# ALTERATION TO A HISTORIC PROPERTY STAFF REPORT

Site: 117 Washington Street c. 1783 Samuel Ireland House

Case: HPC 2017.100 Single Building Local Historic District

Date of Application: December 11, 2017 Legal Notice: Install new fence

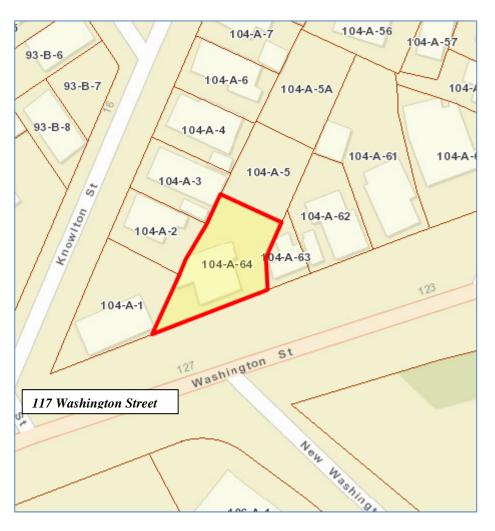
Staff has been working with the Applicant to match historic photos of 19<sup>th</sup> century working class houses similar to what might have been used. See photos below for the intended outcoe and the most recent attempt to replicate the fence style.

Based on the information provided and an assessment of the proposal against the Somerville LHD Guidelines, Staff does recommend <u>APPROVAL</u> of a Certificate of Appropriateness to install a historically appropriate fence to enclose the yard.
